Product Change Notification

Change Notification #: 119649-00

Change Title: Select Intel® Ethernet Server, and Intel® Ethernet Network Adapters, PCN 119649-00, Product Design, Label Swap Bracket Configuration and Add Controller Substrate 2nd Source

Date of Publication: August 21, 2023

Previous Configuration X710T2LG1P5	New Configuration X710T2LG1P5
<p>Full-height bracket installed Low-profile bracket included in the package</p>	<p>Low-profile bracket installed Full-height bracket included in the package</p>

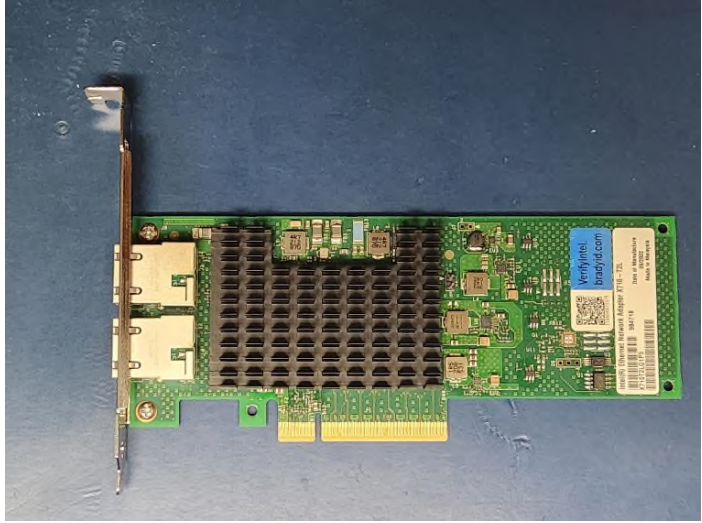
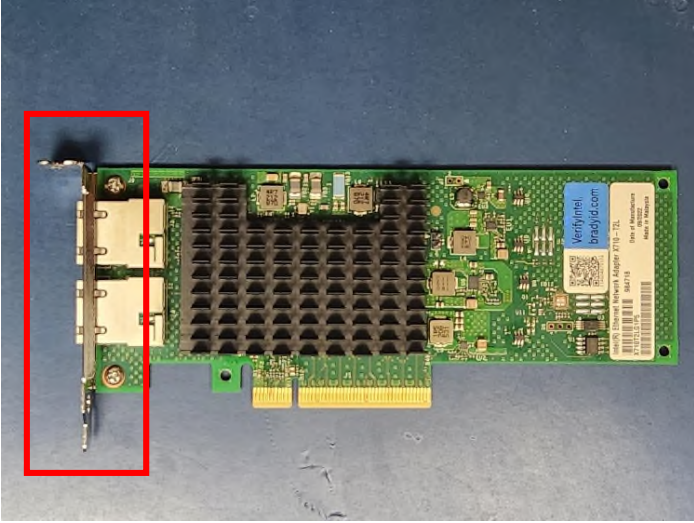
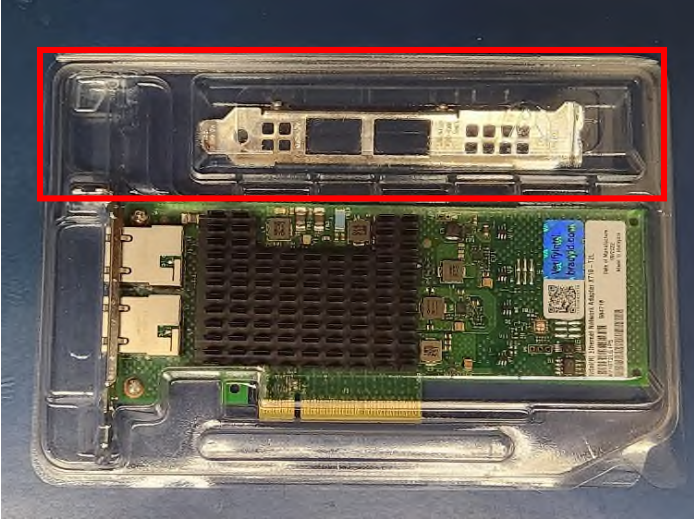
1. The bracket shipping configuration will change for Intel® Ethernet Network Adapter X710-T2L, Intel® Ethernet Network Adapter X710-T4L and Intel® Ethernet Server Adapter I350-T2 OEM Gen products. These products will now ship with the Low-profile bracket installed on the adapter and the Full-height bracket loose in the clamshell pocket.

Previous Configuration X710T4LG1P5

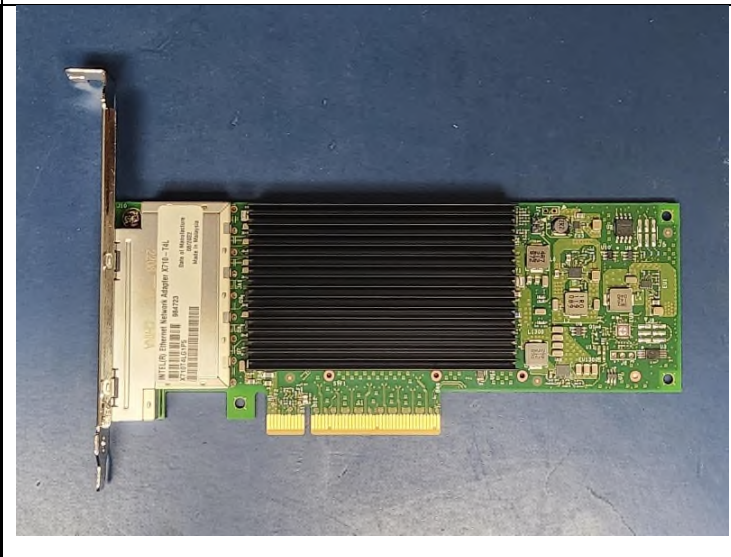
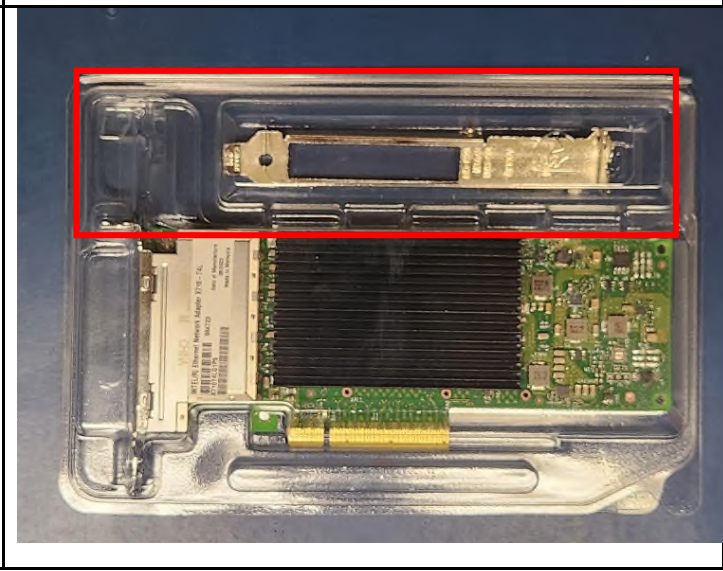
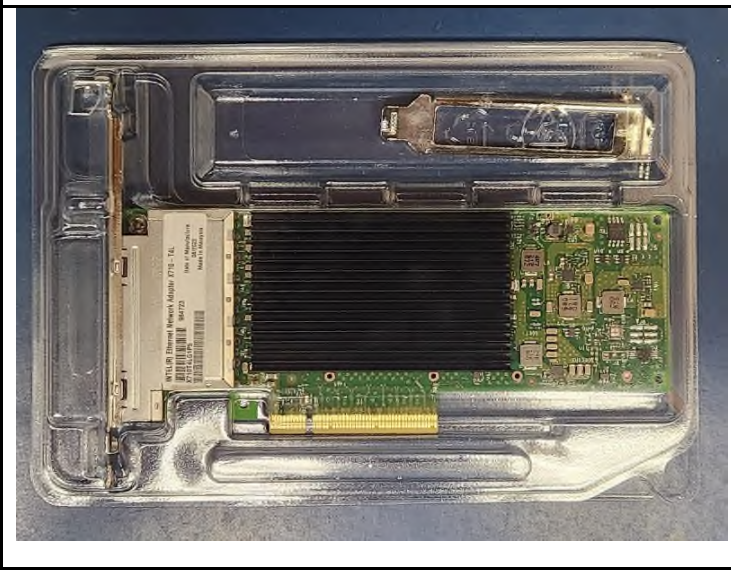
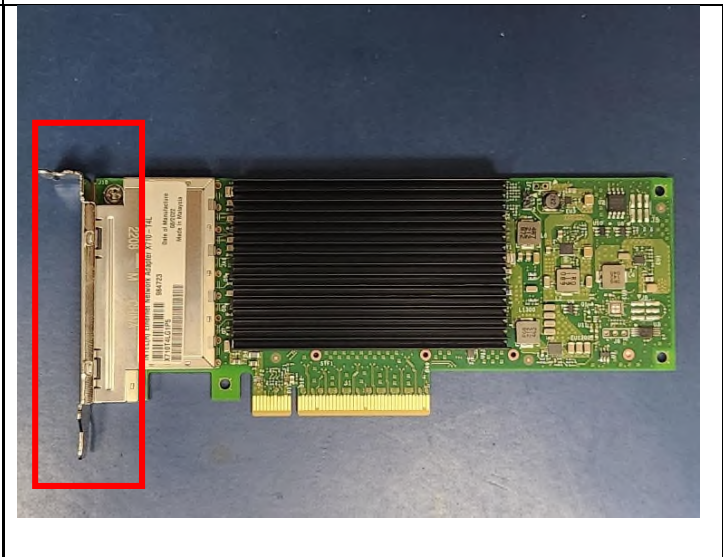
Full-height bracket installed
Low-profile bracket included in the package

New Configuration X710T4LG1P5

Low-profile bracket installed
Full-height bracket included in the package

Previous Configuration I350T2G2P20

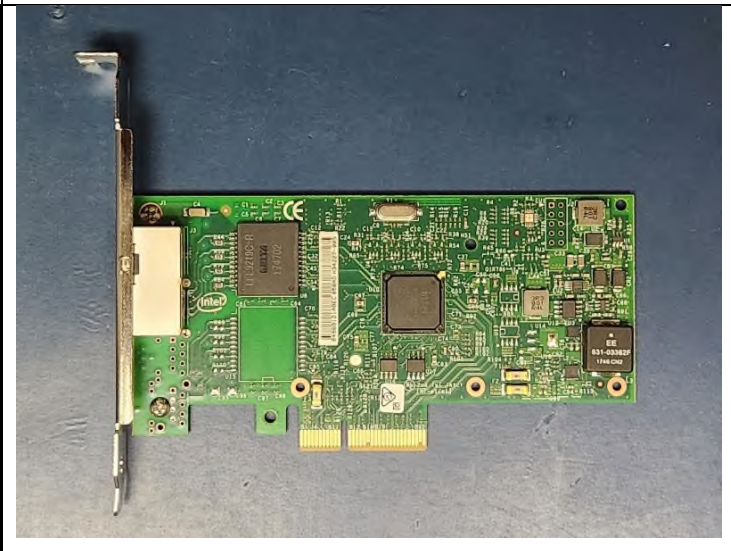
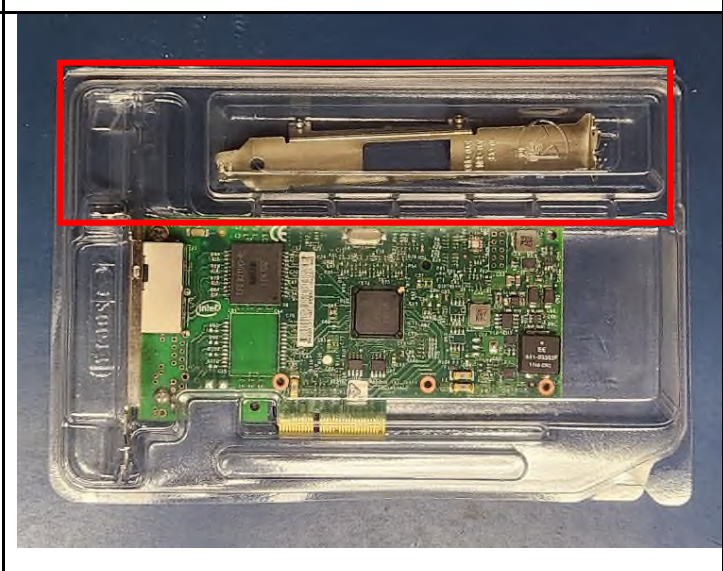
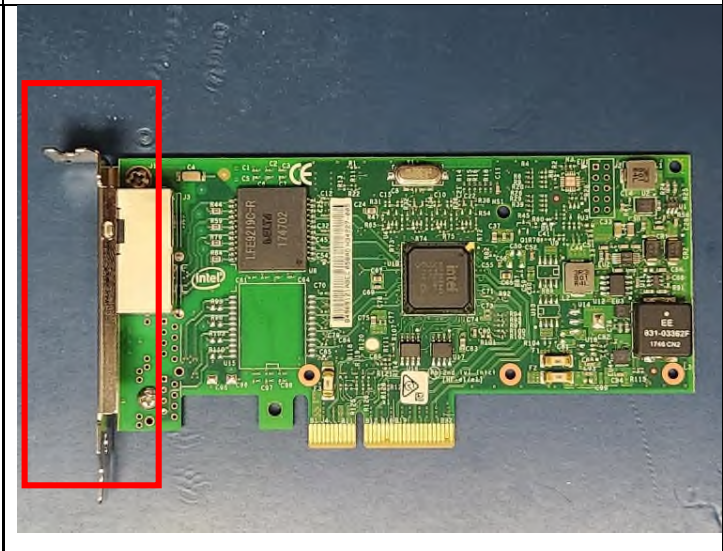
Full-height bracket installed
Low-profile bracket included in the package

New Configuration I350T2G2P20

Low-profile bracket installed
Full-height bracket included in the package
